Re: Appeal of Planning Commission Decision (File No. 17-206-385)
Property Location: 1973-1977 Marshall Avenue, St. Paul

We represent Mary Anderson, Dean M. Nelson, and Scott Van Wert, members of the Historic Merriam Park Neighborhoods group, in connection with the Appeal of the Planning Commission's decision approving the Site Plan application for the above-referenced apartment project (the "Project"). We respectfully request that the City Council reverse the decision of the Planning Commission regarding the Project's Site Plan submitted by MCR Property Holdings, LLC (the "Developer") and instead deny approval of said Site Plan.

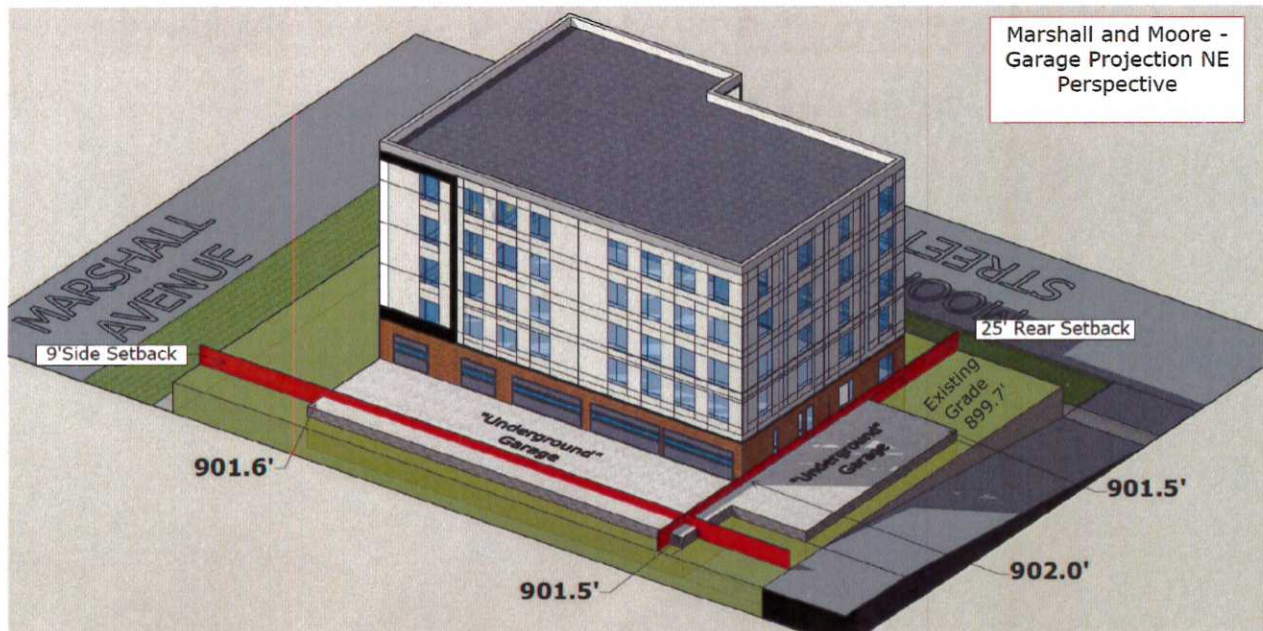
There is no dispute that the proposed lower level parking structure extends nearly 2 feet above the current (i.e., existing) established grade at the property in certain areas. There is also no dispute that unless the grade at the property is raised next to the walls of this parking structure, it will not comply with the Zoning Code’s setback requirements for rear and interior side yards. Specifically, the parking structure is a “Building” under the Zoning Code,² and unless it is at or below grade, the setback requirements must be measured from the face of this structure to the relevant lot line and it violates the applicable setback requirements.

The Planning Commission and city staff apparently determined that the Developer would be permitted to raise the height of the existing grade at the property to ensure that the full height of the parking structure is at or below grade. This determination ignores the plain language of the Zoning Code which expressly prohibits a party from raising the existing grade of the property “to comply with the height requirements of this code.” Leg. Code § 60.203-B.

That is precisely what the Developer is attempting to do in this case. As shown by the image below, the actual height of the proposed lower level parking structure is well above the existing grade and the only way to make it appear to be at “zero feet” above grade is to raise the existing grade around it.

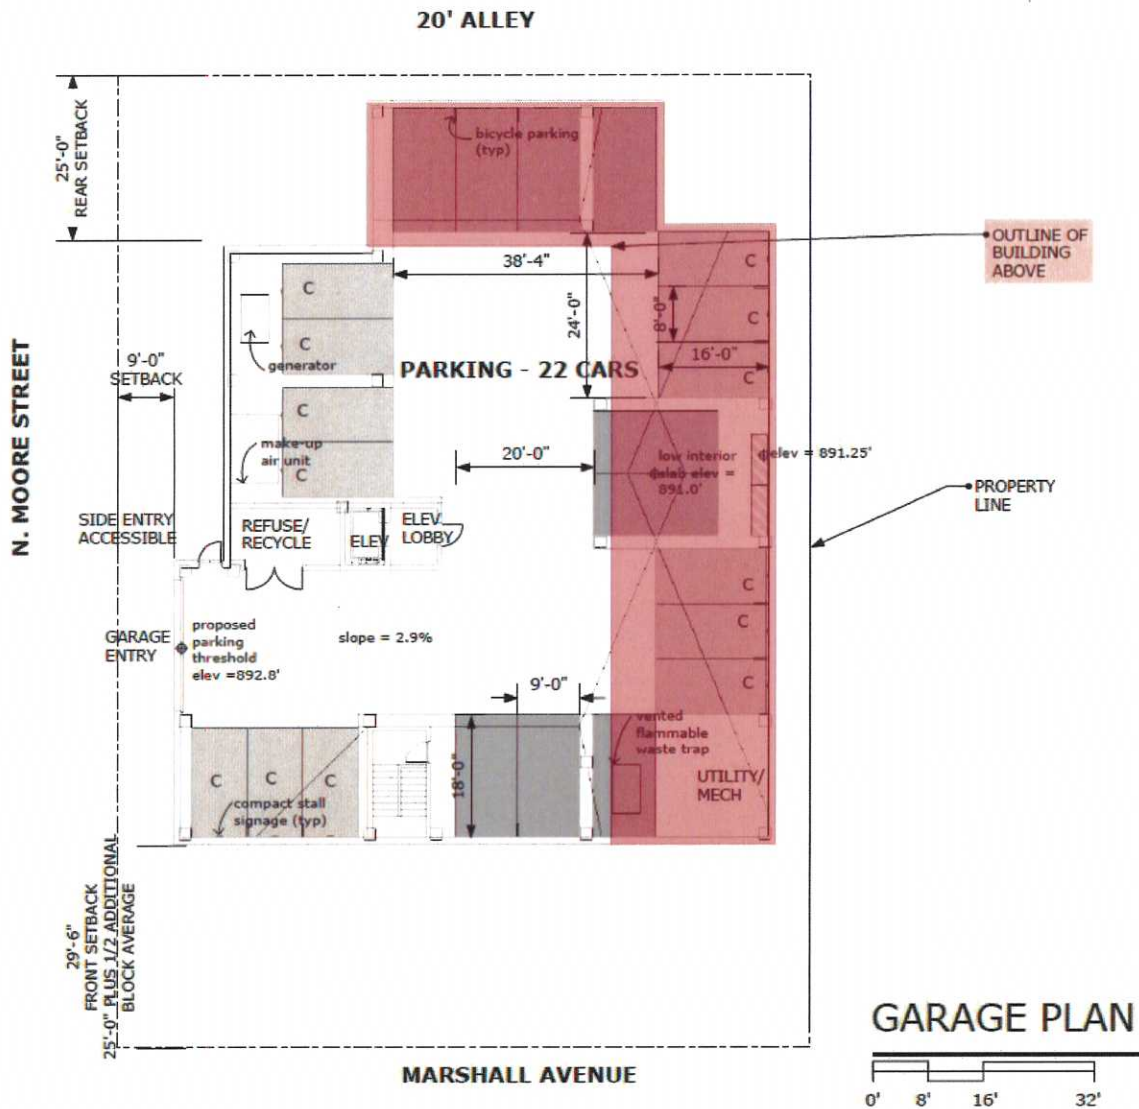
The Developer proposes a total of 30 structured parking spaces for this Project in two parking facilities—8 spots in an above-ground parking structure and 22 spots in a parking structure that the Developer claims is “underground.” However, as is clear from the Developer’s plans, 13 of the 22 spots in the lower level parking facility are not “within a multiple-family structure” or “completely underground.”

First, 13 of the 22 parking spots in the lower level parking facility are clearly not “within a multiple-family structure.” The garage plan shown below clearly demonstrates that the 13 shaded parking spots fall outside the foot print of the proposed multiple family structure and instead encroach on the eastern side yard and rear yard. As such, no “lot area bonus” may be granted for these 13 spots because that they are not “within a multiple-family structure.”
